City of Mercer Island

# ADA Transition Plan

2022

<b>Appendix A Standards Review Barrier Audit</b> .....	60
<b>Appendix B Existing Data Inventory</b> .....	122
<b>Appendix C Prioritization Criteria</b> .....	131
<b>Appendix D Facilities &amp; Parks Survey Report</b> .....	144
<b>Appendix E Stakeholder Engagement</b> .....	533
<b>Appendix F Planning Cost Estimate Backup</b> .....	572
<b>Appendix G Facility Prioritization Criteria</b> .....	579
<b>Appendix H Accessible Pedestrian Signal (APS) Policy</b> .....	587
<b>Appendix I Grievance Procedure</b> .....	589
<b>Appendix J Maximum Extent Feasible Documentation Template</b> .....	591
<b>Appendix K ADA Terminology</b> .....	595

<b>CITY OF MERCER ISLAND</b> <b>STANDARD DETAILS</b> <b>STREETS</b>		
<b>WHEELCHAIR RAMP</b> <b>TYPICAL LOCATION AND STYLES</b>		
11/23/99	NO SCALE	<b>ST-21</b>

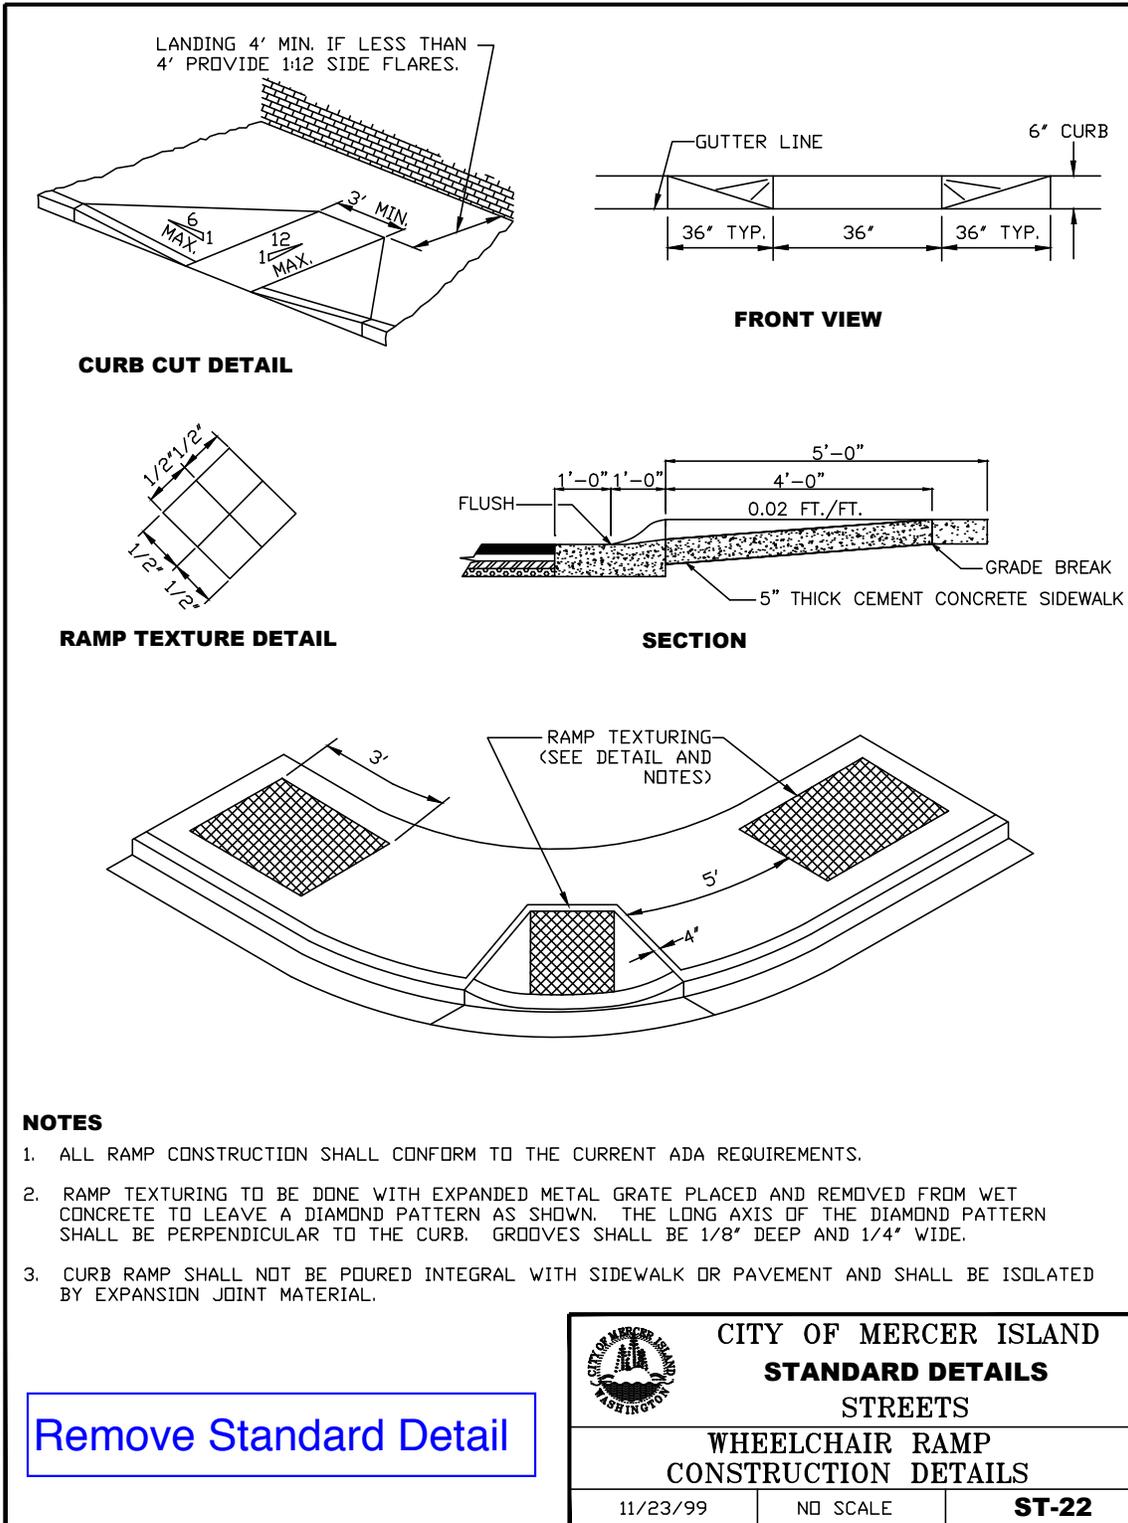
Remove Standard Detail

<b>CITY OF MERCER ISLAND</b> <b>STANDARD DETAILS</b> <b>STREETS</b>	
	<b>COMBINATION</b> <b>CURB RAMP B</b>	
8/14/2015	NO SCALE	<b>ST-22D-2</b>

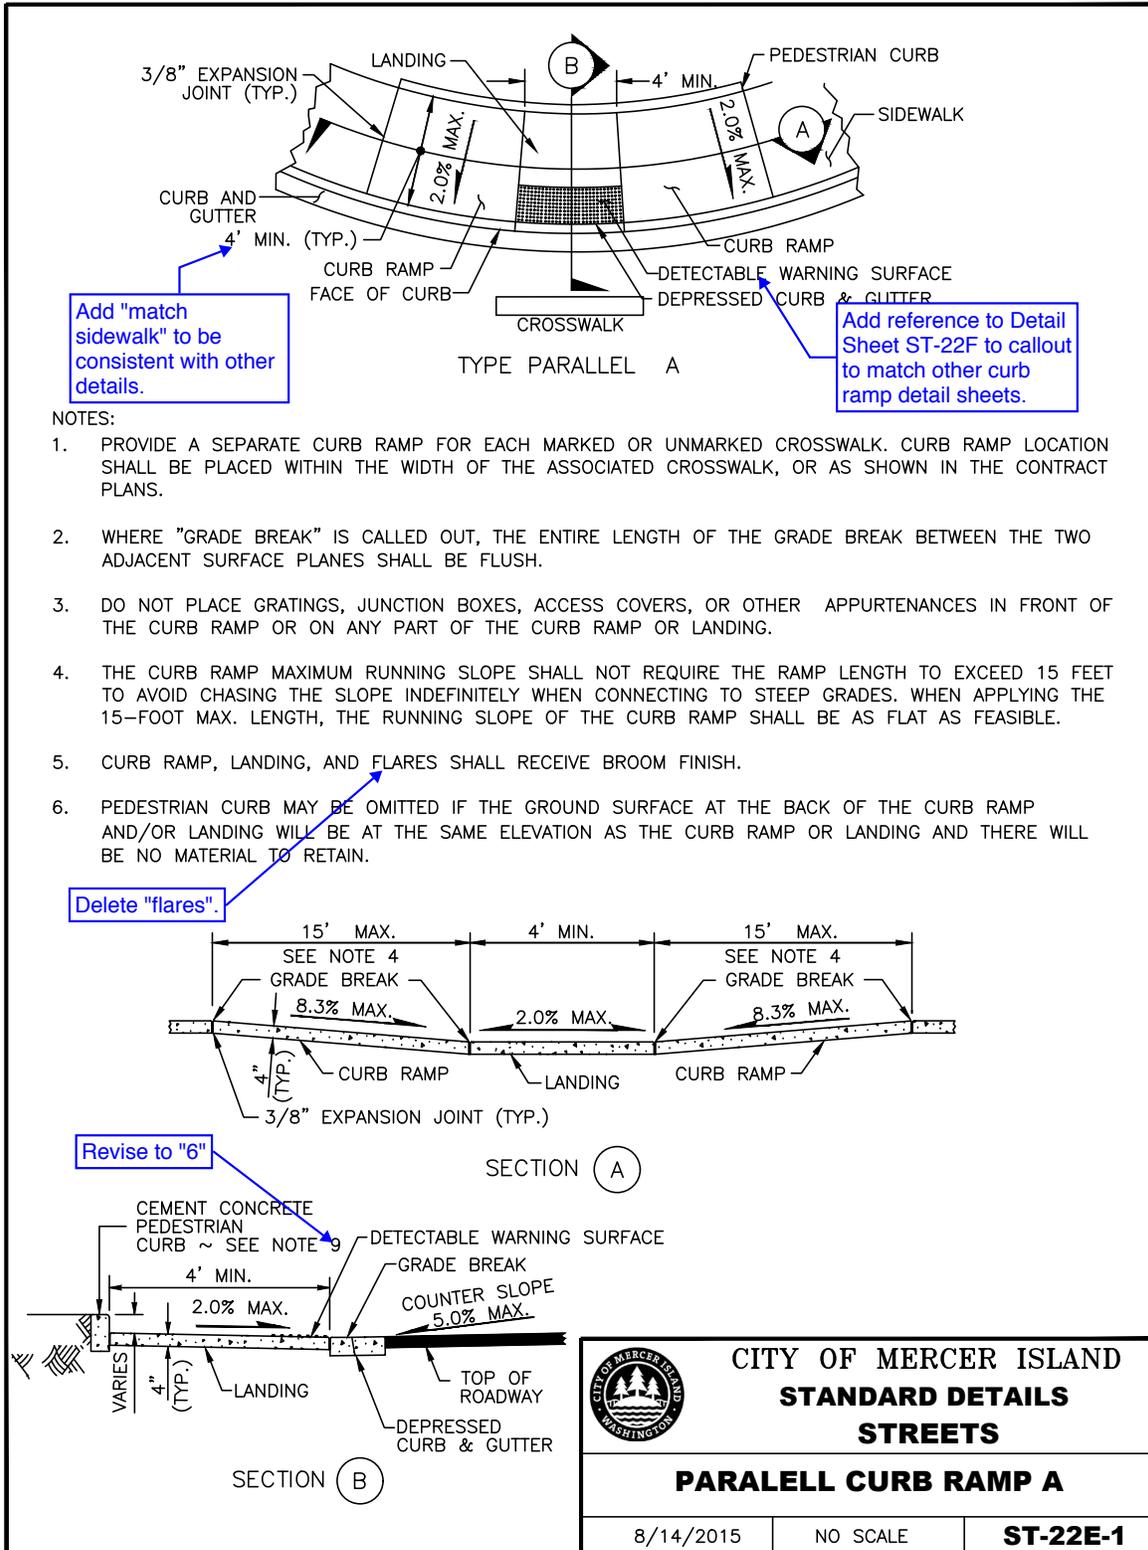
Add section detail going through landing perpendicular to curb line or reference detail from Parallel Curb Ramp A.

Add reference to Detail Sheet ST-22F to callout to match other curb ramp detail sheets.

<b>CITY OF MERCER ISLAND</b> <b>STANDARD DETAILS</b> <b>STREETS</b>	
	<b>PARALELL CURB RAMP B</b>	
8/14/2015	NO SCALE	<b>ST-22E-2</b>

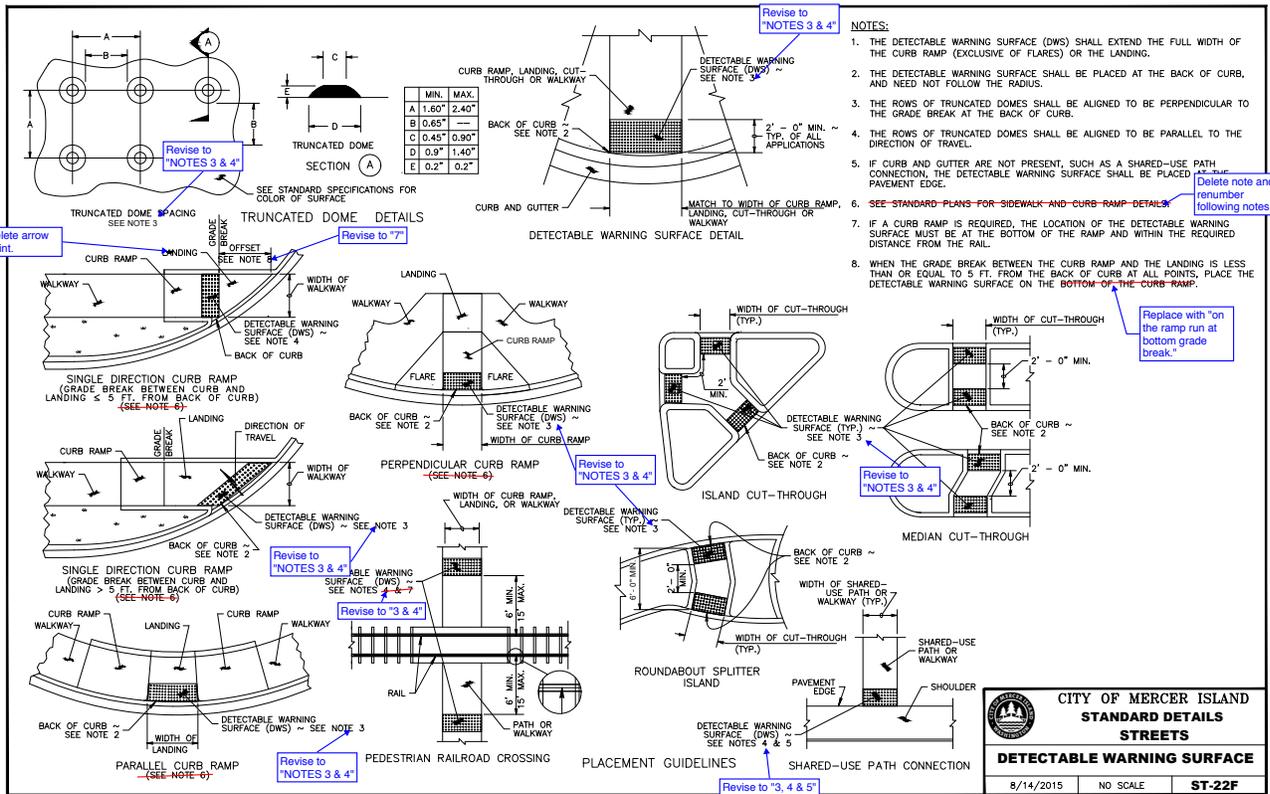
Delete arrow point.

Revise to "NOTES 3 & 4"

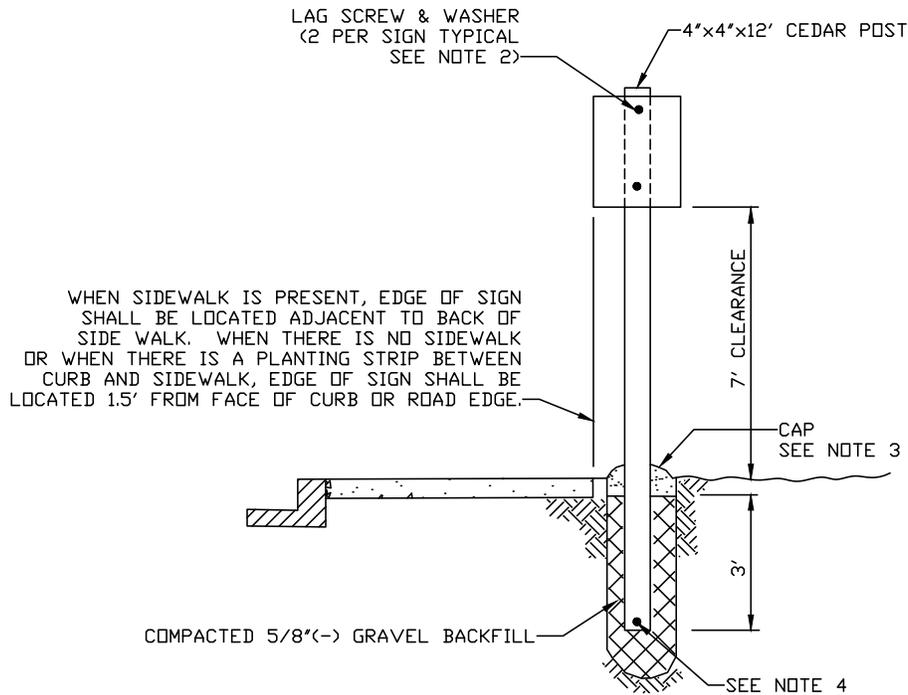
Update references.

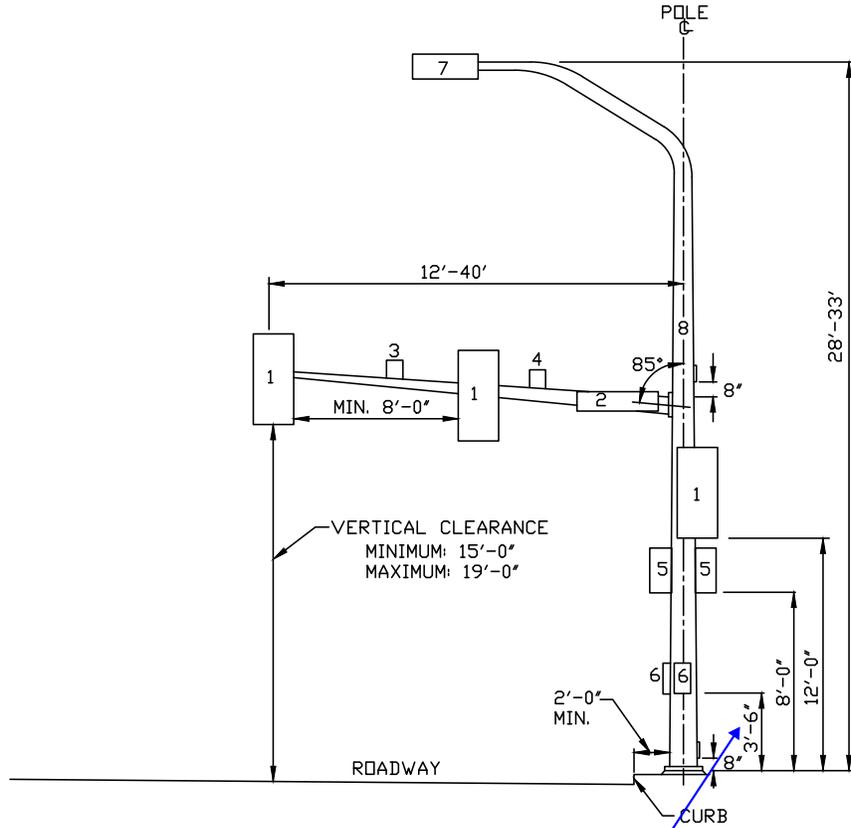
Revise dimension to measure to center of pushbutton.

<b>CITY OF MERCER ISLAND</b> <b>STANDARD DETAILS</b> <b>TRAILS</b>	
	<b>DETAILS</b> <b>CEMENT CONCRETE SIDEWALK</b>	
	11/23/99	NO SCALE

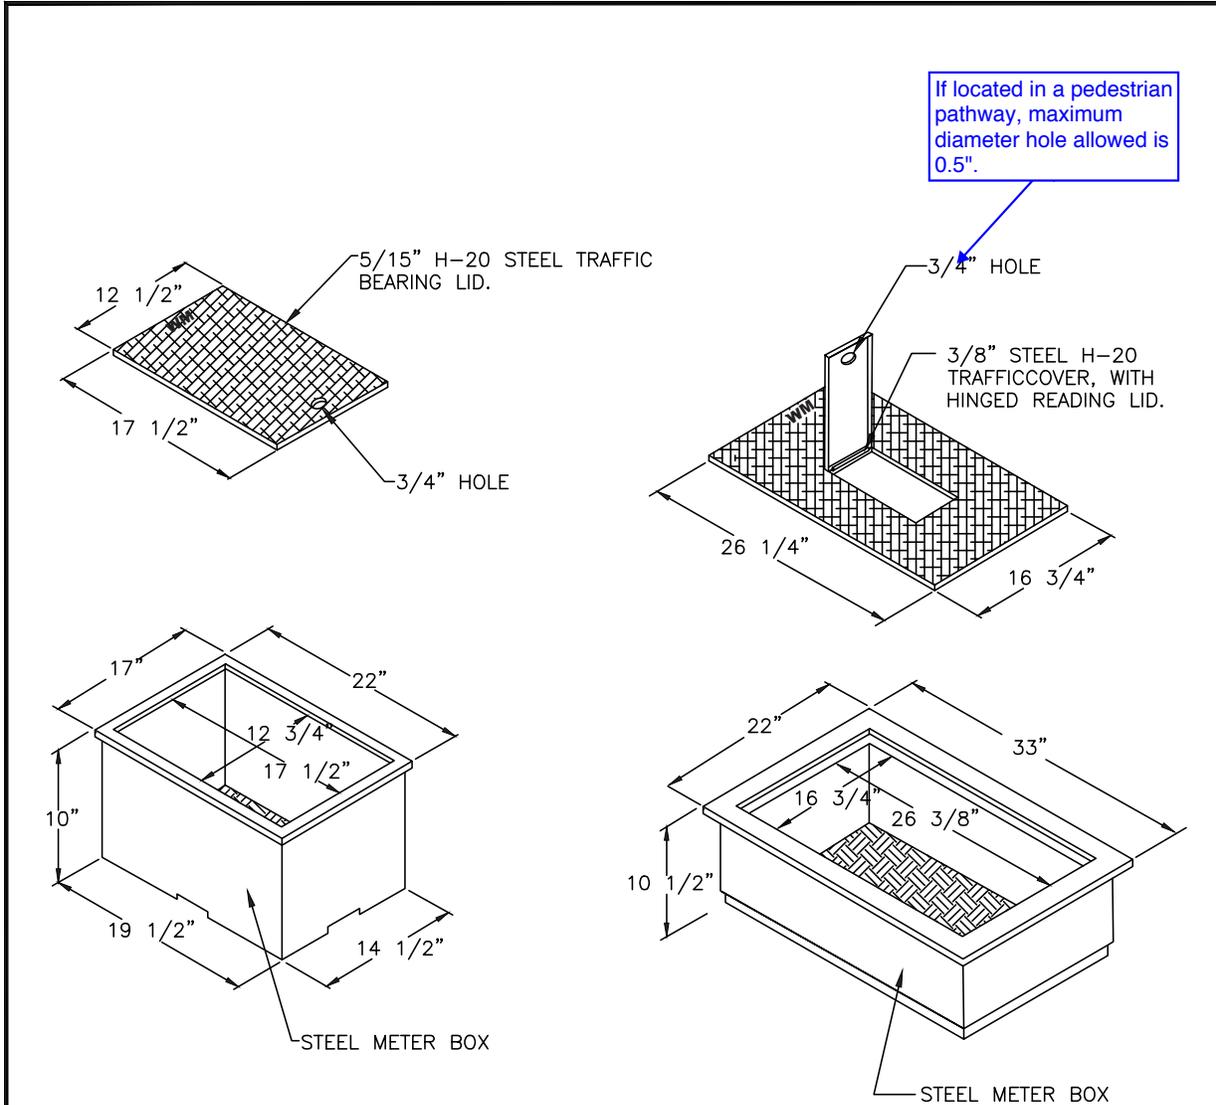
Update reference

Update reference
